Docket No. 50-278

The Commission has issued the enclosed Amendment No. 14 to Facility License No. DPR-56 for Peach Bottom Atomic Power Station Unit 3. The amendment includes changes to the Technical Specifications and is in response to your requests dated July 9, 1975 and Supplements thereto dated September 10, 1975, October 1, 24 and 30, 1975, November 18 and 20, 1975, and December 29, 1975.

PEACH BOTTOM ATOMIC POWER STATION, UNIT 3

Amendment No. 14
License No. DPR-56

FIGURE 3.5.1.C - MAXIMUM AVERAGE LINEAR HEAT GENERATION RATE (MAPLHGR) versus PLANAR AVERAGE EXPOSURE

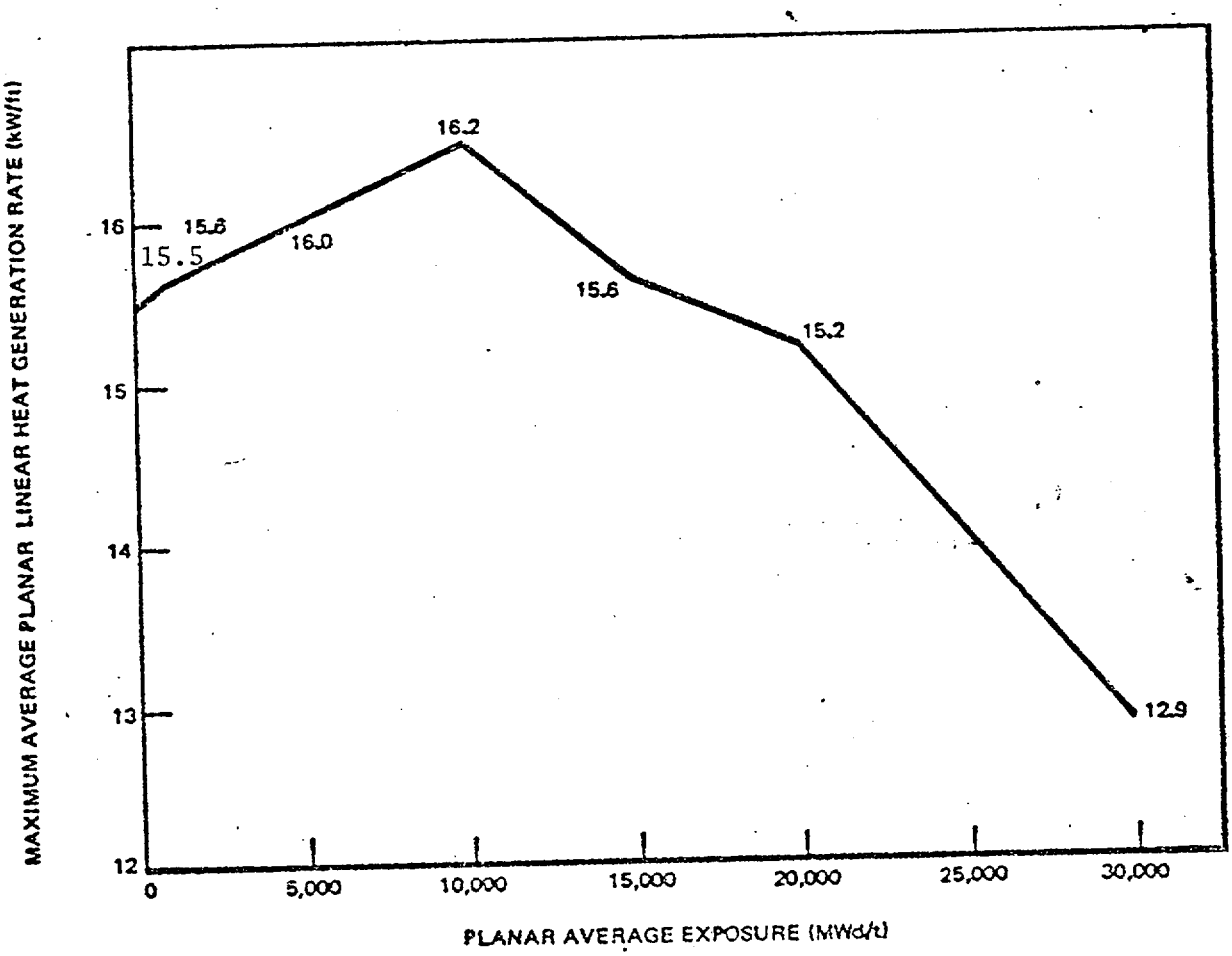
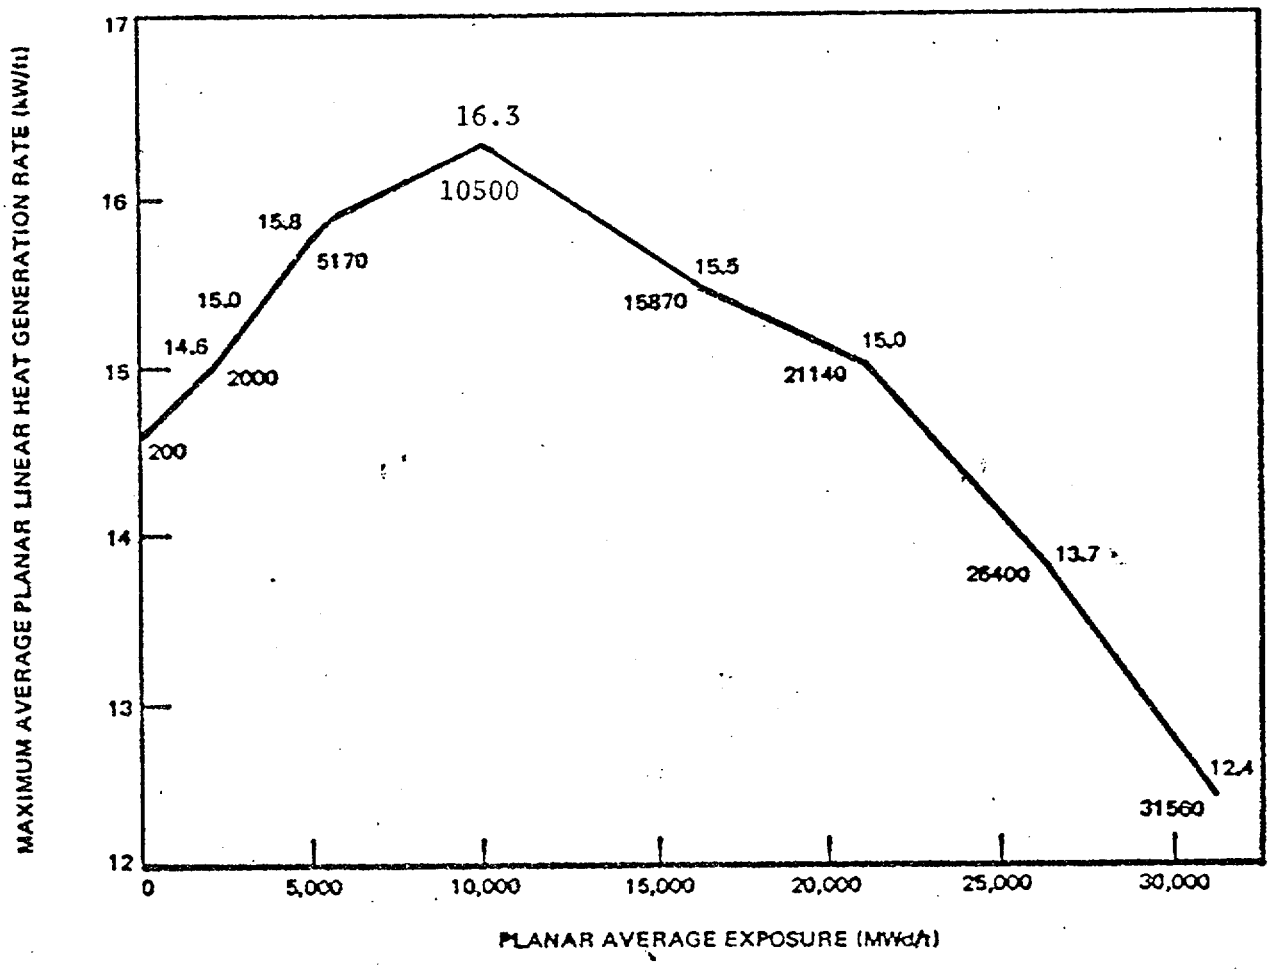
The average planar linear heat generation limits would be revised to be consistent with the analyses performed in accordance with 10 CFR Part 50.46 for operation with plugged bypass holes in the lower core plate.

The calculational procedure used to establish the APLHGR shown on Figures 3.5.1-C and D is based on a loss-of-coolant accident analysis. The analysis was performed using General Electric (GE) calculational models which are consistent with the requirements of Appendix K to 10 CFR Part 50. A complete discussion of each code employed in the analysis is presented in Reference 1. Differences in this analysis as compared to previous analyses performed with Reference 1 are: (1) The analyses assumes a fuel assembly planar power consistent with 102% of the MAPLHGR shown in Figure 3.5.1-C and D; (2) Fission product decay is computed assuming an energy release rate of 200 MEV/Fission; (3) Pool boiling is assumed after nucleate boiling is lost during the flow stagnation period; (4) The effects of core spray entrainment and counter-current flow limiting as described in Reference 2, are included in the reflooding calculations.

FIGURE 3.5.1-E

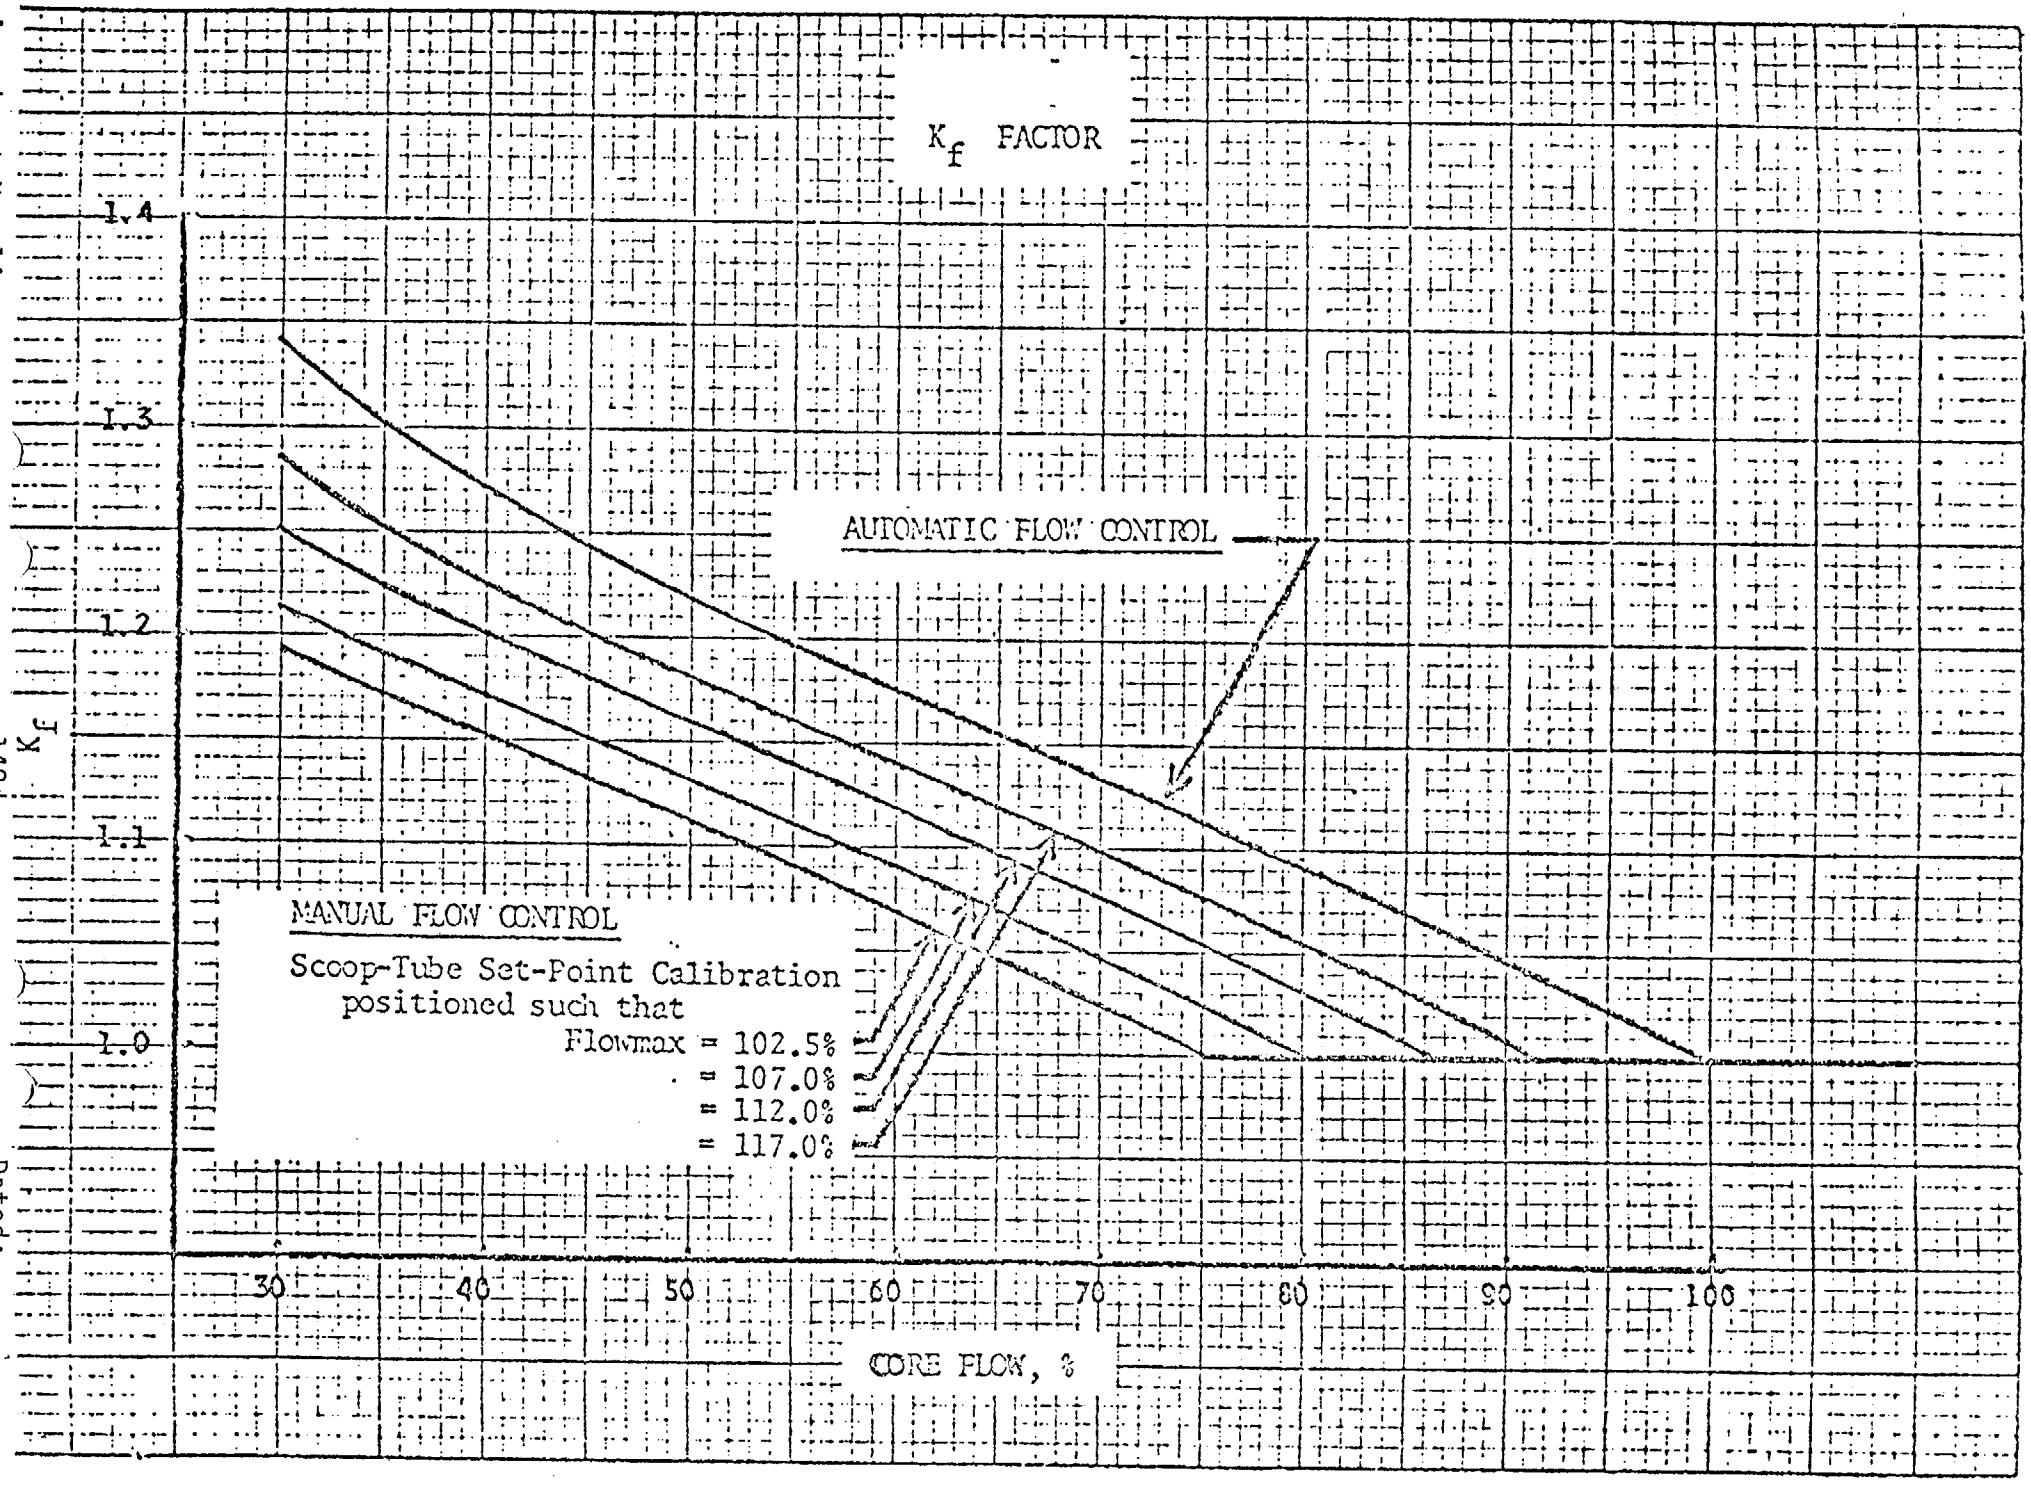
The K_f factors shown in Figure 3.5.1-E, are acceptable for Peach Bottom Unit 3 operation because the operating limit MCPR of 1.25 is greater than the original 1.20 operating limit MCPR used for the generic derivation of K_f.

The K_f factor curves shown in Figure 3.5.1-E were developed generically and are applicable to all BWR/2, BWR/3, and BWR/4 reactors. The K_f factors were derived using the flow control line corresponding to rated thermal power at rated core flow.
